The exhaust/muffler for the generator has little ground clearance—it hangs below the bottom plane of the generator and will not clear most parking lot bumpers when backing into a space. There appears to be adequate space for it above the bottom plane of the generator. This vulnerability to damage could lead to carbon monoxide in the van if it is bumped.

Picture 1

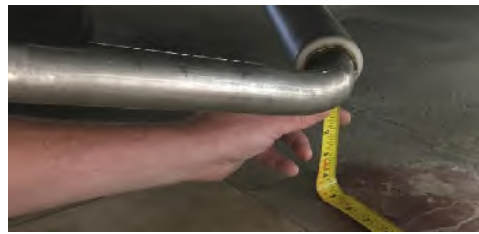
Thank you for your prompt response. I have attached a picture showing the ground clearance of the generator muffler (picture 1). It is about 4 ½” with empty holding tanks and a propane tank at less than half full. Having now been under the Plateau I see the exhaust exits straight down from the generator. An “L” cut would allow a sharper bend, but create a restriction in the diameter of the exhaust system. Is that acceptable?

Although the generator exhaust system on my Plateau is built to your design, I think it is a problem and possibly a safety issue. 4 ½” clearance for an exhaust system without a load is not very much!!

The 4 ½ inches clearance is okay. That is also what we have here in production. See picture above of the generator exhaust from another Plateau TS I took from our production building (picture 2).

If you still want to increase the ground clearance of the gen exhaust you may do so by taking this to your dealer or a local muffler shop for the work. "An “L” cut would allow a sharper bend, but create a restriction in the diameter of the exhaust system. Is that acceptable?" Yes, because there still enough space for you to make the cut on the pipe to make the height adjustment without restricting the exhaust system.
